## **CALIFORNIA COASTAL COMMISSION**

A-2-MAR-21-0048 (GRONEMAN/SIBLEY SFD)

FEBRUARY 10, 2023

## **EXHIBITS**

**Figure 3:** Cross-section of a composite coastal bluff with steep lower sea cliff (composed of resistant rock) and more gently-sloping upper bluff (composed of terrace deposits).

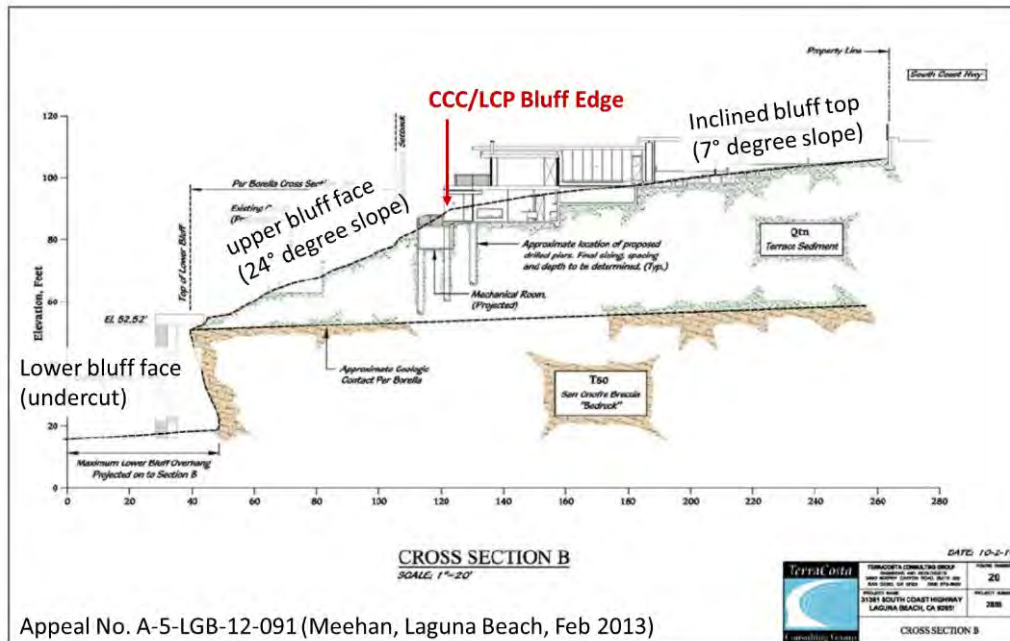
In numerous previous determinations, the Commission has interpreted the Section 13577(h) and similar definitions in LCPs to mean that a coastal bluff encompasses the entire slope between an upland area and the beach or shore, not just the steepest portion of the slope or the part of the slope experiencing marine erosion. Many coastal bluffs consist of a steep lower bluff, or sea cliff, where marine erosion is occurring, as well as a more gently sloping upper bluff where subaerial erosion processes also contribute to the bluff profile. An example of one such coastal bluff is shown in **Fig. 3**, above. The location of the Commission-determined bluff edge is indicated at the top of the upper bluff slope. In this example, at a location where the bluff top itself is inclined, the bluff edge is the point beyond which the downward gradient exceeds the general gradient of the bluff top.

**Figure 4** (left). Aerial image of project area with topographic contours. Contour spacing decreases seaward of Sunset Wy., indicating steeper slopes.  
(Source: <https://gis.marinpublic.com/arcgis/rest/services>)

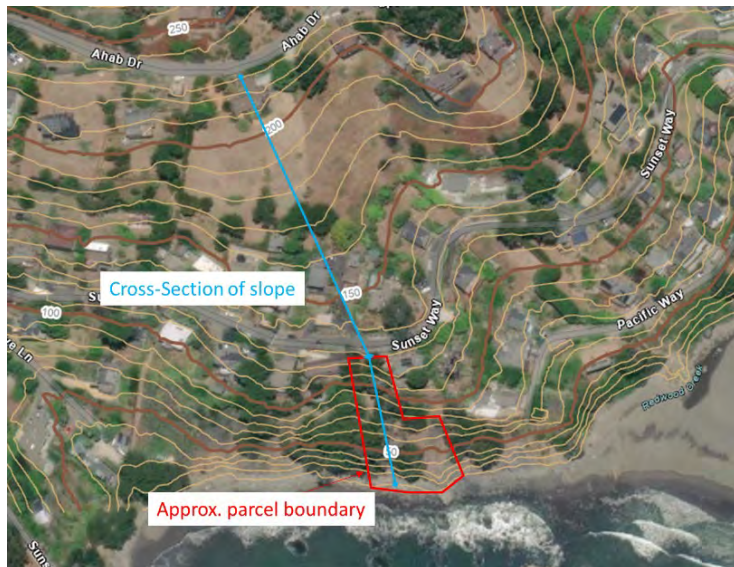
At the subject site, applying the LCP and Commission bluff edge definitions is complicated by the nature of the coastal landform. The project site is located on an arm of the coastal mountains where it intersects the coast, and lacks the level “bluff top” (often an uplifted marine terrace) characteristic of many coastal locations. Nonetheless, as shown in **Figs. 4** and **5** (below), the inclination of the local landform increases substantially moving seaward across the site, with a major change in slope (“slope break”) occurring just seaward of Sunset Way.

**Figure 5** (below): Cross-sectional profile of the coastal bluff at the project site based on topographic contours shown in Fig. 4.

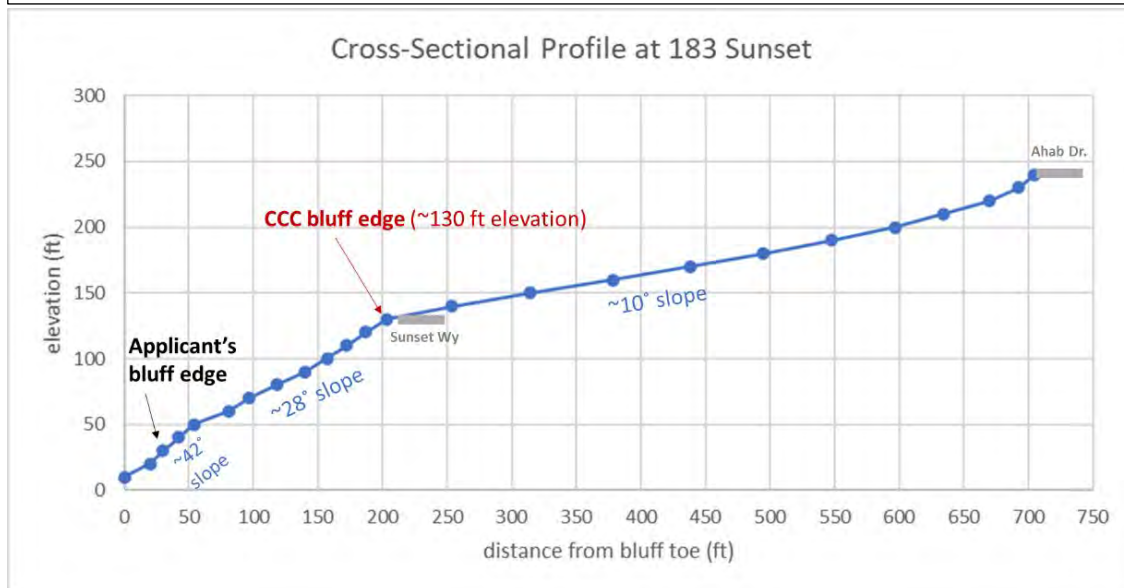
The applicant's geologic reports (Refs. 1, 2) identify the bluff edge as the top of the steep lower portion of the bluff, at elevations ranging from +26 – 34 ft MSL across most of the site and increasing to +56 ft MSL on the southeastern flank (**Figs. 1, 2**). This bluff edge line appears to correspond to an erosional scarp associated with recent marine erosion of the bluff toe, and as such is important for the evaluation of potential bluff retreat over the life of the proposed project. However, the applicant's bluff edge delineation does not account for the long upper bluff slope that comprises most of the property (the upper ~100 feet of elevation), nor its relatively steep inclination (~2:1 h:v), which, beginning just seaward of Sunset Way, significantly exceeds that of the gentler slope inland of the road (~6:1 h:v). In the context of the larger local landform, there is a *second* significant slope break, inland and uphill of the applicant's bluff edge line, that represents the point "beyond which the downward gradient of the surface increases more or less continuously until it reaches the general gradient of the cliff", per the Commission and County bluff edge definitions. In my judgement, this upper slope break, at approximately +132 ft elevation,

best represents the bluff edge as defined in Section 13577(h) of the Commission's regulations. Applying the LCP bluff edge definition, the bluff edge determination also should account for prior grading and discount any fill that has been placed near or over historic/natural bluff edge. According to Ref. (1), several feet of fill was placed along the downslope edge of Sunset Way, and it is likely that the grading of the road also altered the natural topography at or near the original bluff edge. Without knowing the exact landform modifications that took place, it is difficult to identify the "original" or "natural" bluff edge, and I recommend the use of the existing 132 ft elevation contour, as shown in the applicant's site plan, as the bluff edge reflecting current topography.

Figure 1 – Site Plan with Bluff Edges

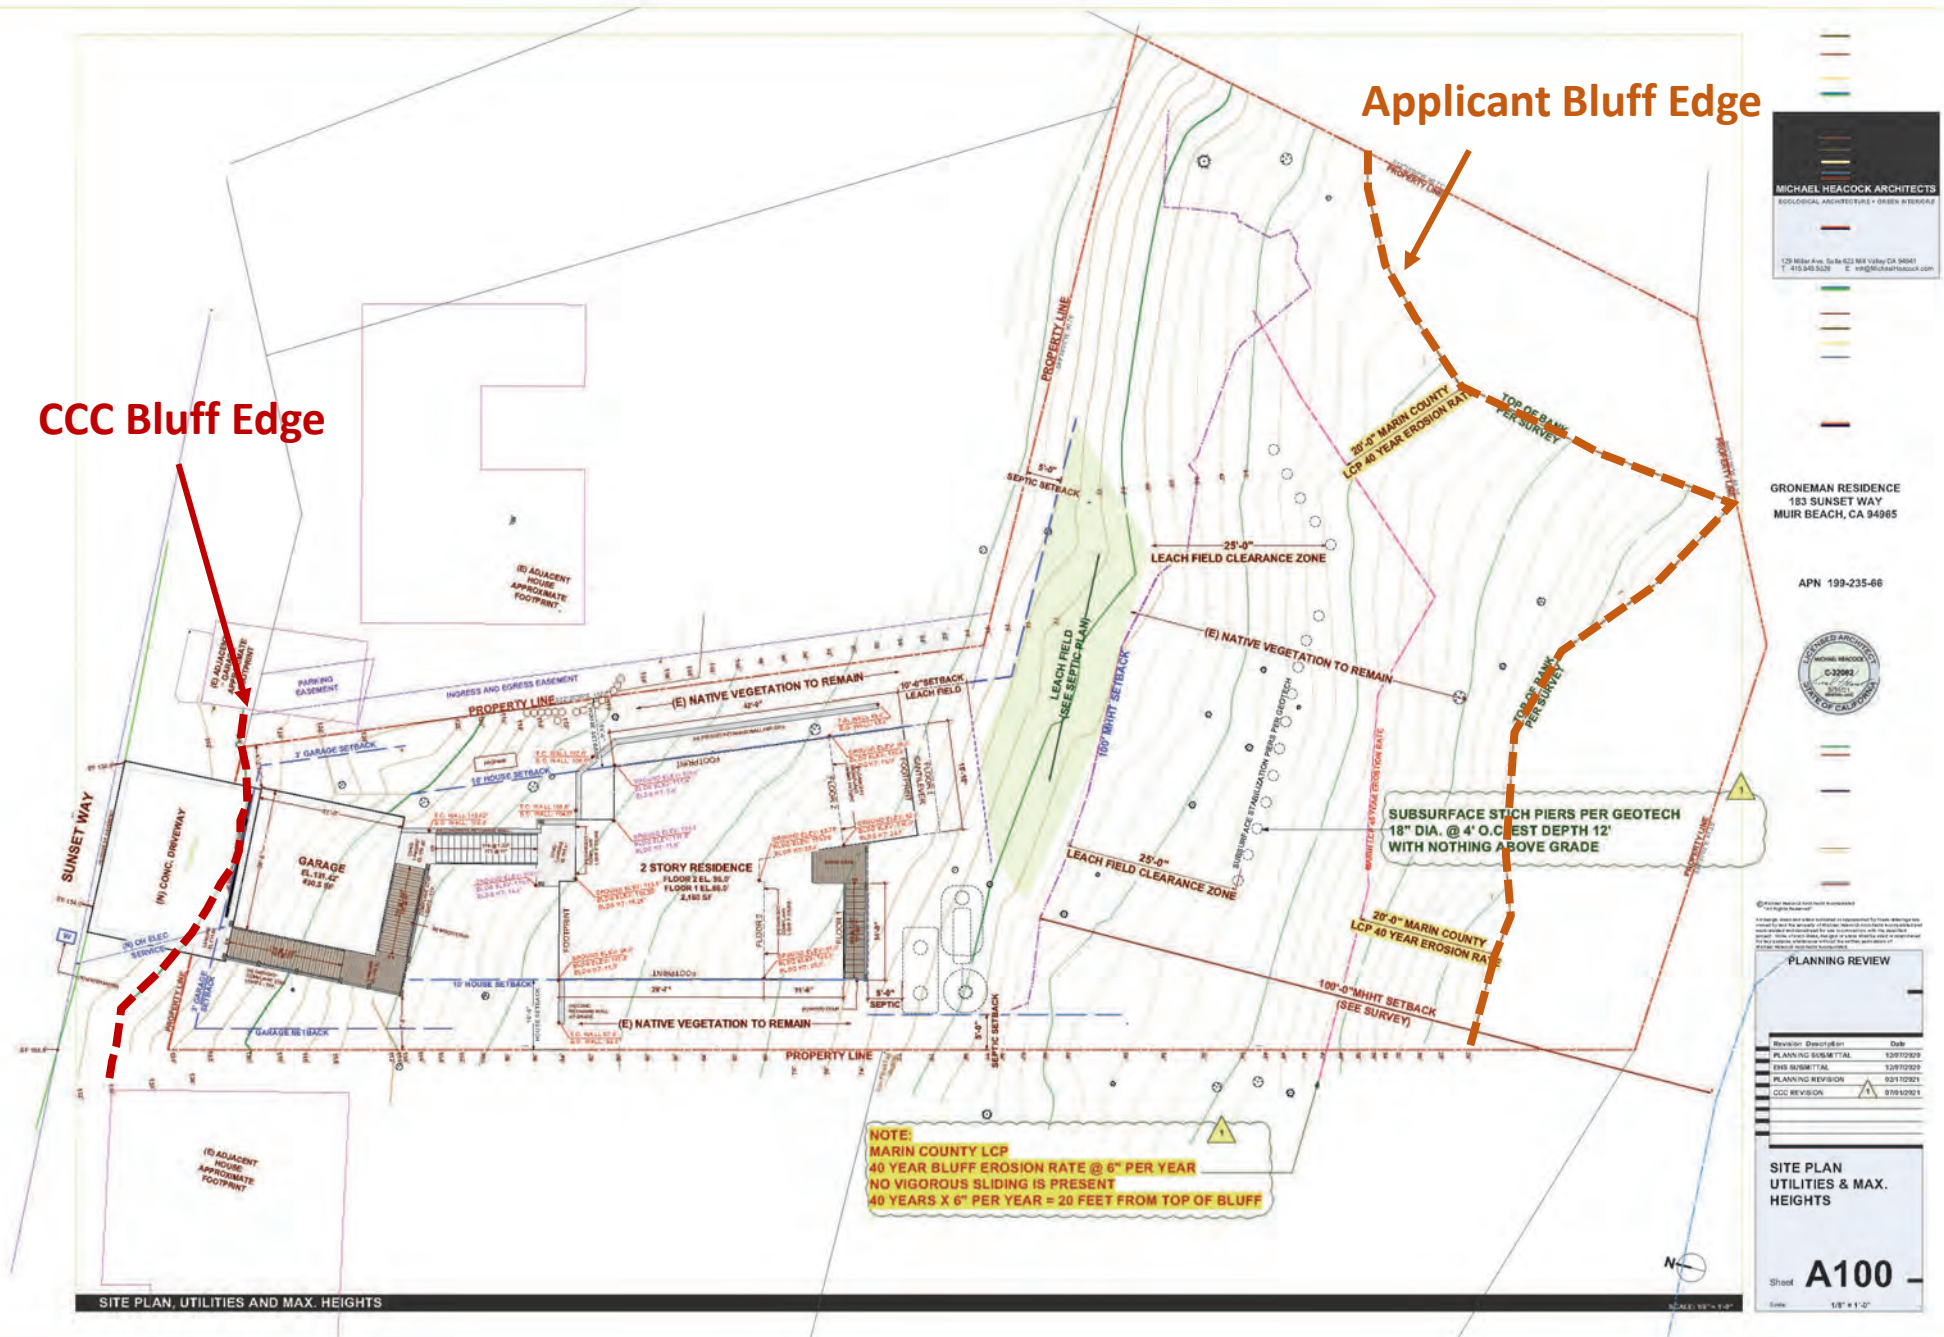
As laid out in the LCP and Section 13577(h), the topographic criterion I have used to define the bluff edge ("that point nearest the cliff beyond which the downward gradient of the surface increases more or less continuously until it reaches the general gradient of the cliff") is to apply in cases where the bluff edge is "rounded away from the face of the cliff as a result of erosional processes related to the presence of the steep cliff face". The bluff profile at the subject site lacks a single, abrupt transition point from a relatively level surface to a steep cliff face; rather, the transition occurs gradually, through several smaller changes in slope. This condition is consistent with a bluff edge that is "rounded away" from the cliff face. Moreover, the relatively steep gradient of the slope below Sunset Way appears to be maintained by a combination of marine (wave attack at the bluff toe) and subaerial erosion processes (landsliding, surface water flow, etc.). Based on the site observations of Refs. (1) and (2) and my own site visit, erosion at the bluff toe appears to have triggered several modest slides and surficial failures on the lower portion of the upper slope, and it is likely similar or larger slope erosion events triggered by marine erosion have occurred in the past. In my estimation, the relatively steep upper bluff slope occupied by the subject property has likely been shaped by recurrent shallow landslides over time, and is the result, at least partially, of erosional processes related to the presence of the steeper portion of the lower bluff.
